**AGENDA
PLANNING & ZONING COMMISSION
TUESDAY, OCTOBER 28, 2014**

**MINUTES OF THE REGULAR MEETING
OF THE PLANNING & ZONING COMMISSION
OF THE CITY OF ROWLETT, TEXAS, HELD IN THE MUNICIPAL CENTER
4000 MAIN STREET, AT 6:00 P.M., OCTOBER 14, 2014**

Staff Report

Conduct a public hearing and take action on a request for a Major Warrant pertaining to lighting standards for the Homestead at Liberty Grove located at 9401 Princeton Road, 27 Princeton Road and 8701 Liberty Grove Road, being 103.95 +/- acres in the James M Hamilton, Abstract 544, Page 560, Tract 23 and 26.4, Rowlett, Dallas County, Texas.

Attachment 1- Proposed Preliminary Plat

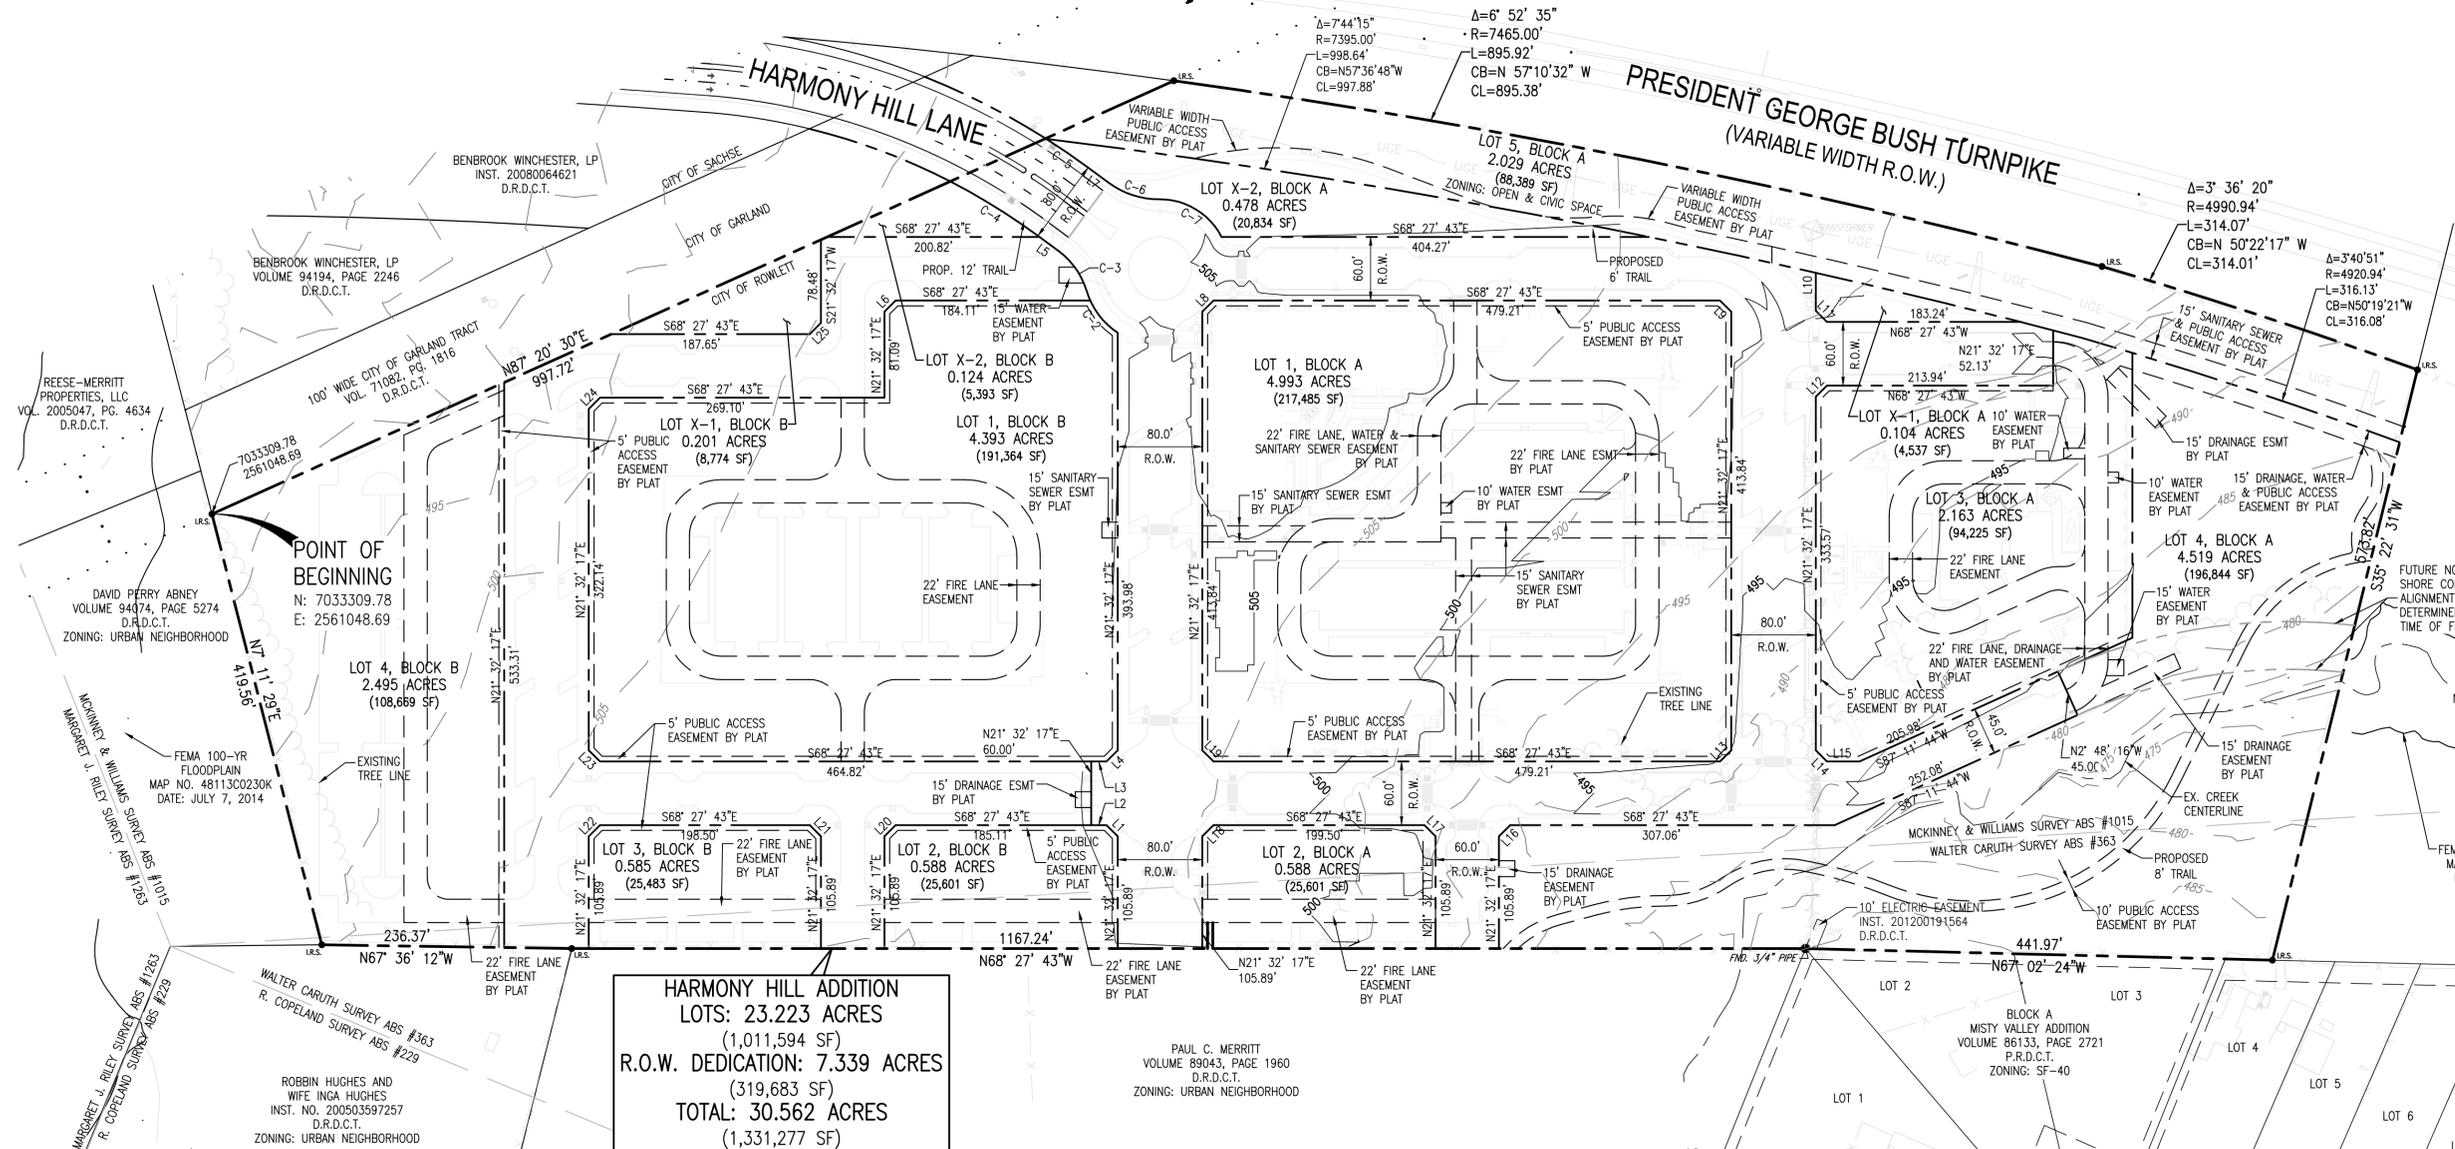
The preliminary plat (Attachment 1) is one of the first steps in the development process and provides an overview of the utility and street layout for the site in its entirety. In the future, the final plats associated with this site will be required to be in conformance with the approved preliminary plat. In the case of Harmony Hill, the project is being platted as 13 lots to accommodate 4 phases and provide for open space lots. The intended use of the property is a 650-unit mixed residential (apartment) development.

City Staff from the Planning and Engineering Divisions as well as the Fire Marshal’s Office have reviewed the preliminary plat for compliance with the Rowlett Development Code. Based on the fact that this request meets the requirements set forth in the Rowlett Development Code, staff recommends approval of this request.

Staff recommends the Planning and Zoning Commission approve the proposed preliminary plat.

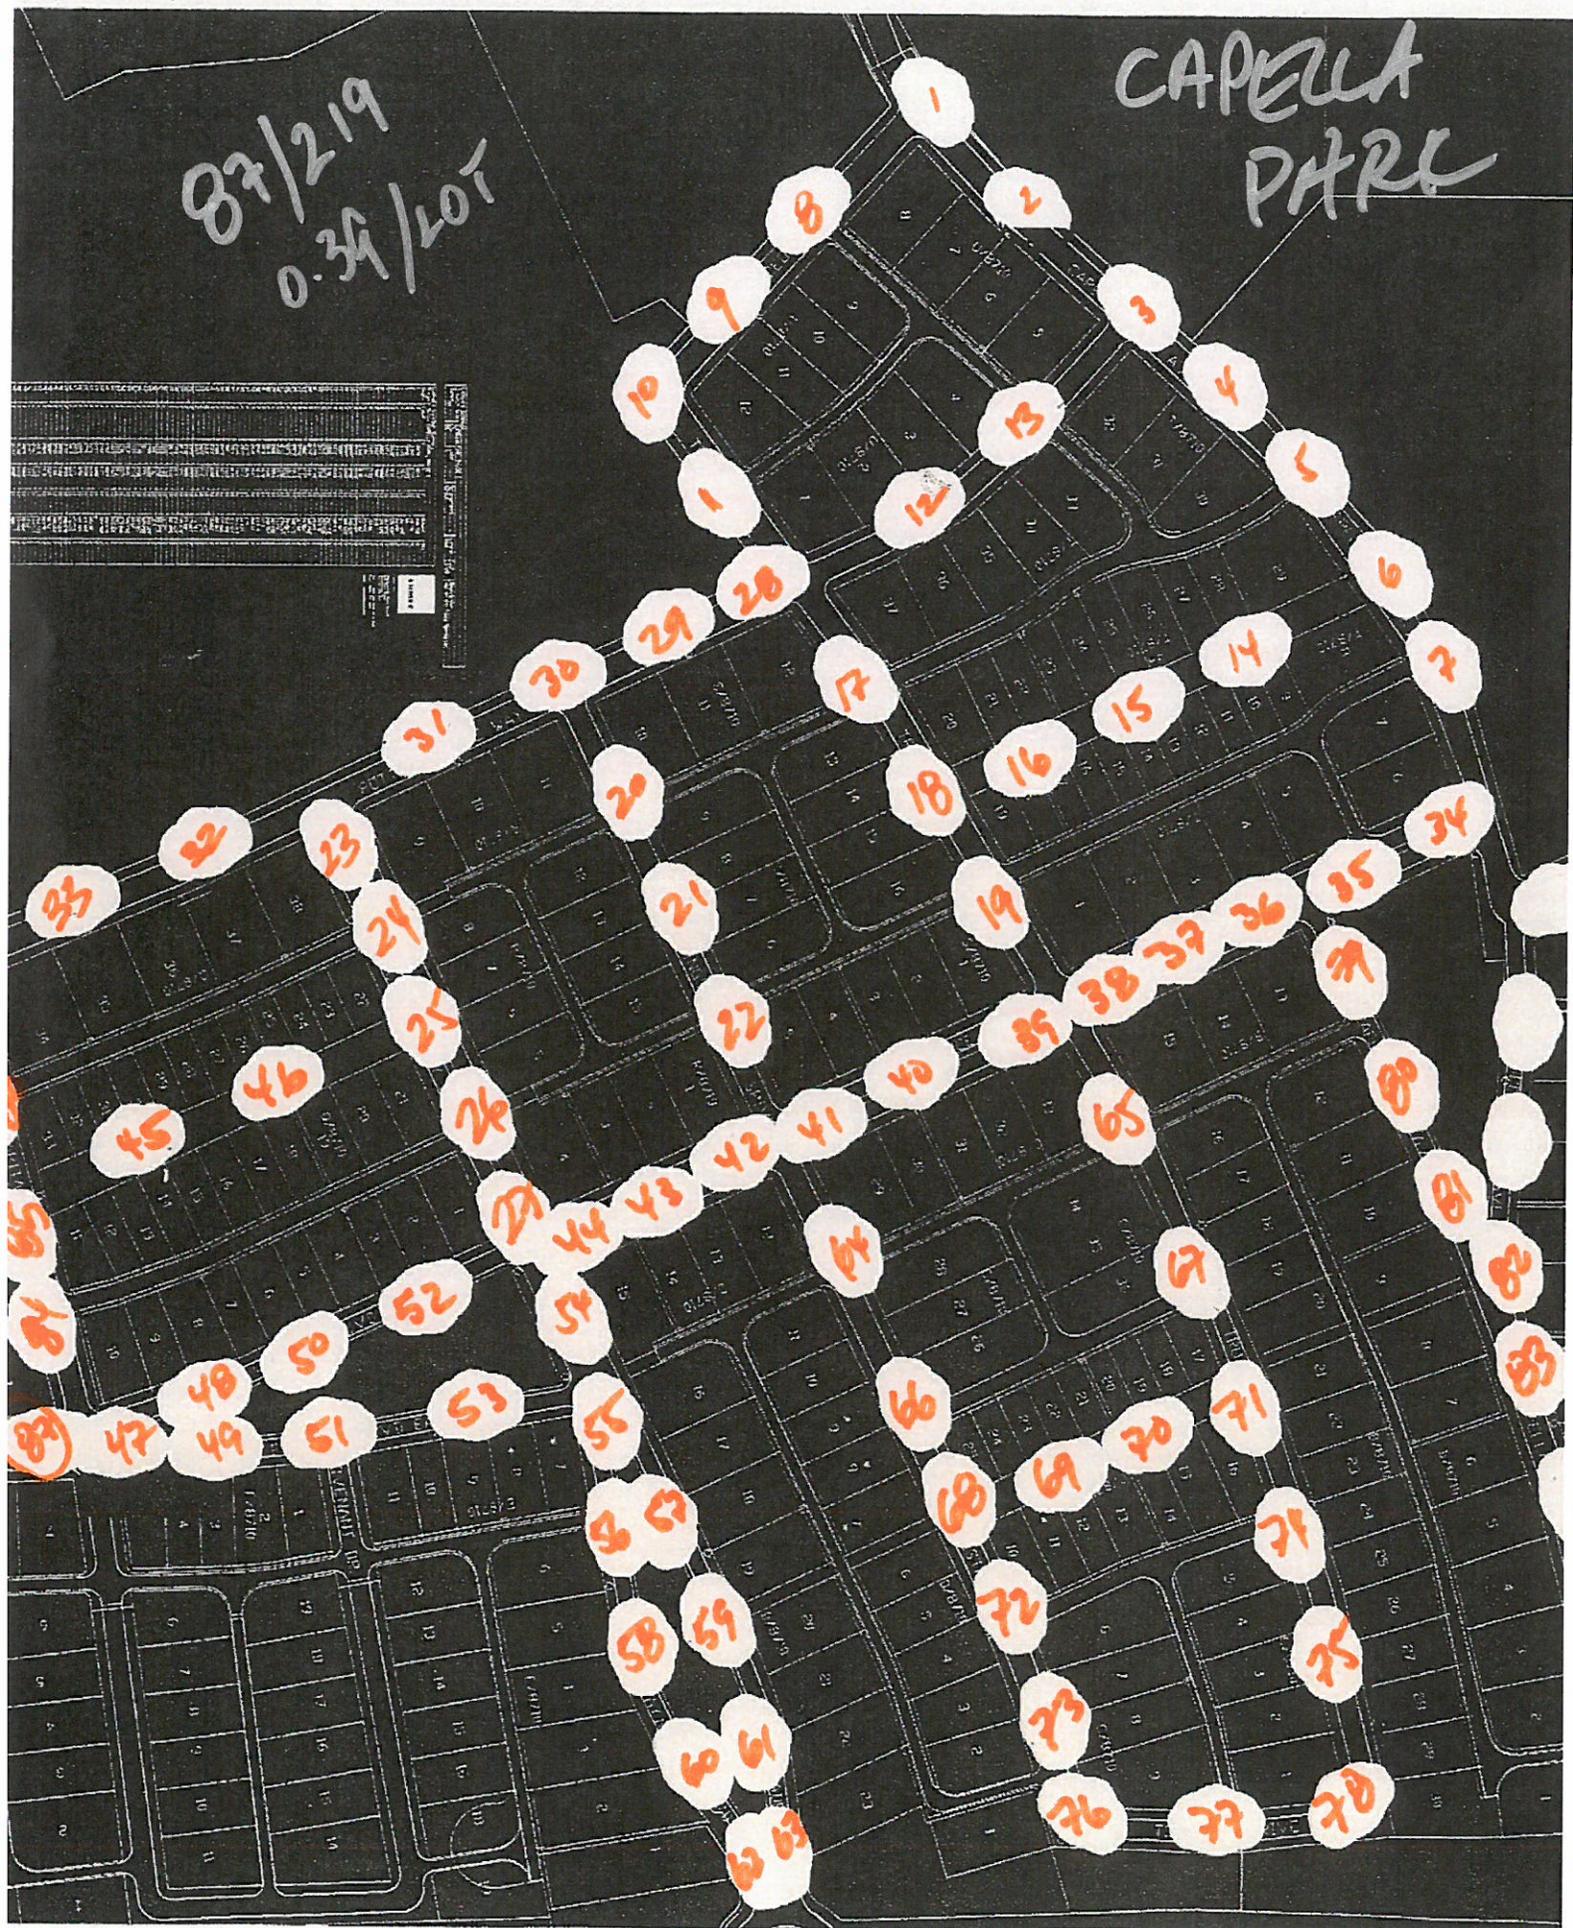
In light of The Homestead at Liberty Grove Major Warrant request additional research has been conducted on residential neighborhoods. Specifically Capella Park, a new urbanist neighborhood in Dallas, Texas was used in compiling this recommendation. The density and product mix found in Capella Park would fall under the New Neighborhood standards. Within Capella Park, one pedestrian level light is provided for approximately every two lots. Based on input from the City's lighting specialist, Capella Park is achieving a 0.5-foot-candle average throughout the neighborhood.

Added research evaluating the City of San Francisco's street lighting standards for residential neighborhoods indicate that the pedestrian lighting level range is 0.3 fc to .4 fc. And further, that no pedestrian level light spacing requirements were designated. For Rowlett, the average lighting level along sidewalks and trails, without intruding on adjacent homes, is of

In light of the above analysis, the FBC should be amended in the future to correct the lighting standard for the New Neighborhood FB District. Until that amendment is made, the Major Warrant process is the most appropriate avenue for deviating from the adopted standard. As such, I recommend approval of The Homestead at Liberty Grove Major Warrant request.

A2.4
EXTERIOR ELEVATIONS

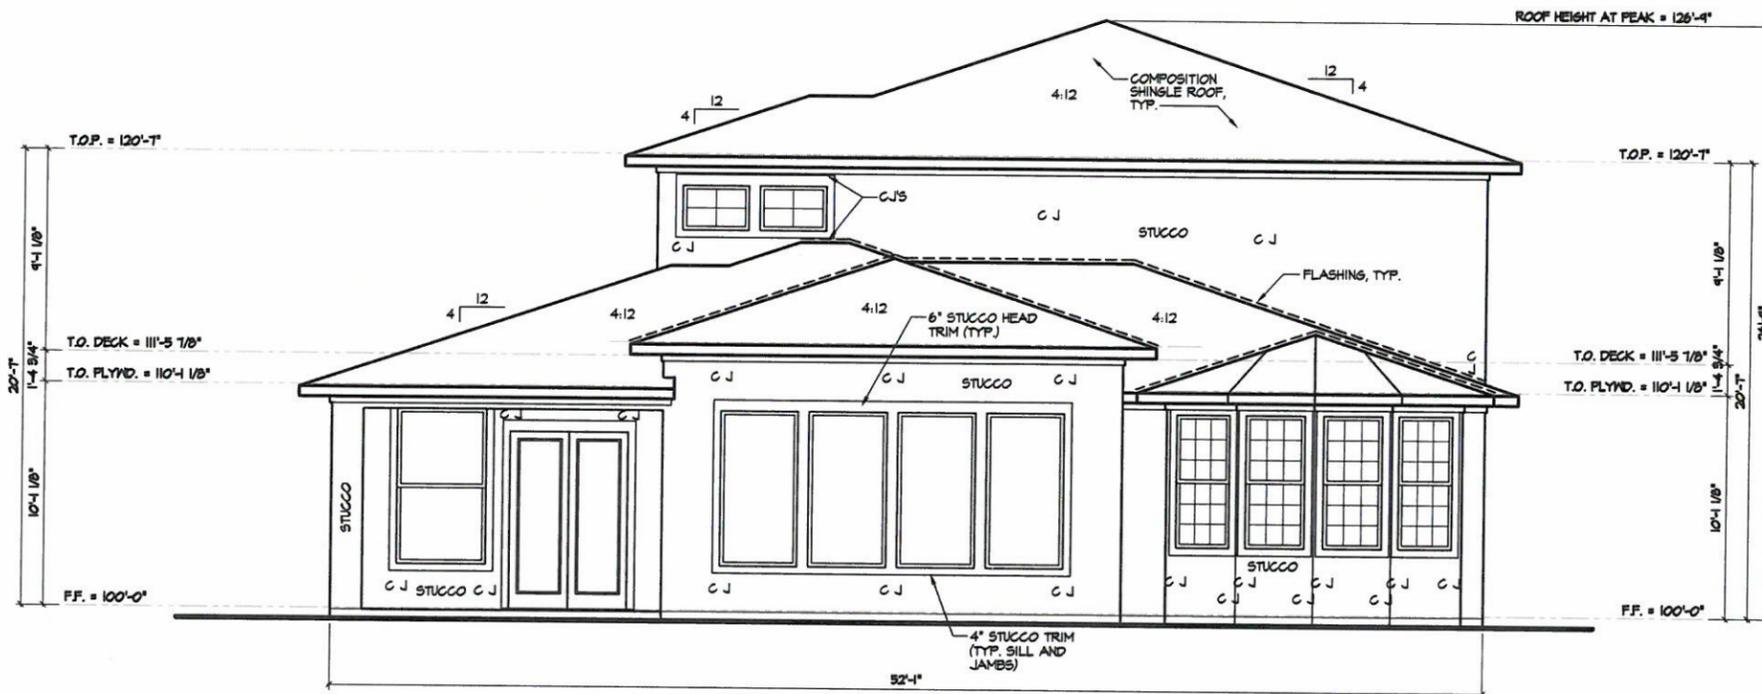
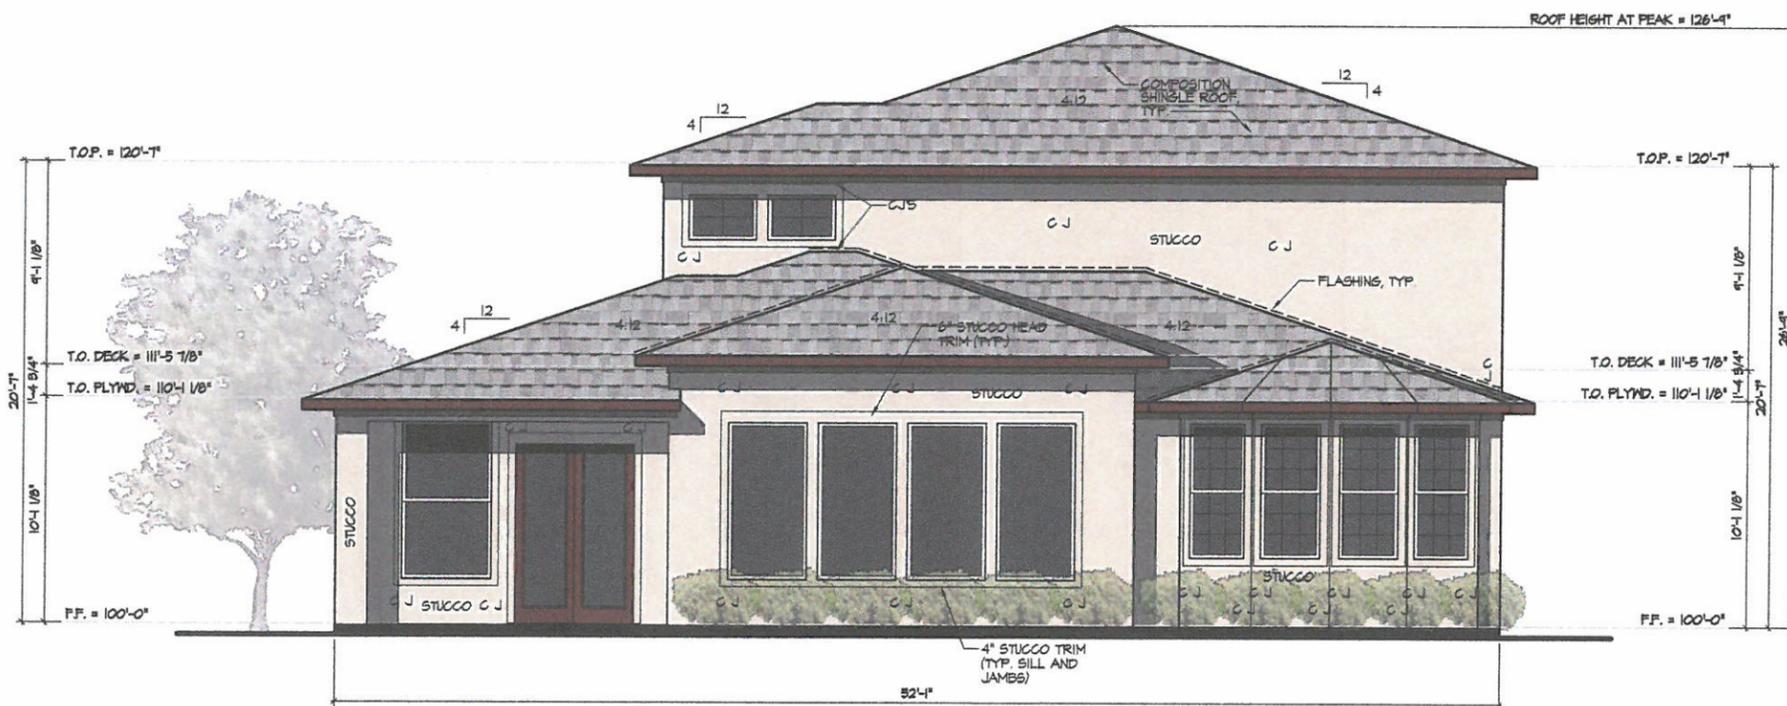
This is an Alternative Building Material (ABM) request to allow a new single family home utilizing stucco as one of the main exterior materials. Per the Rowlett Development Code (RDC), new single family construction requires 100 percent brick and/or stone exterior. Alternative materials such as stucco may be recommended by the Planning and Zoning commission and may be approved by the City Council.

Considering the quality of the material and the existence of similar architecture within close proximity to the subject property, Staff finds the request is acceptable and meets the intent of the Rowlett Development Code.

Staff recommends the Planning and Zoning Commission make a favorable recommendation on the alternative building material request for stucco to City Council.
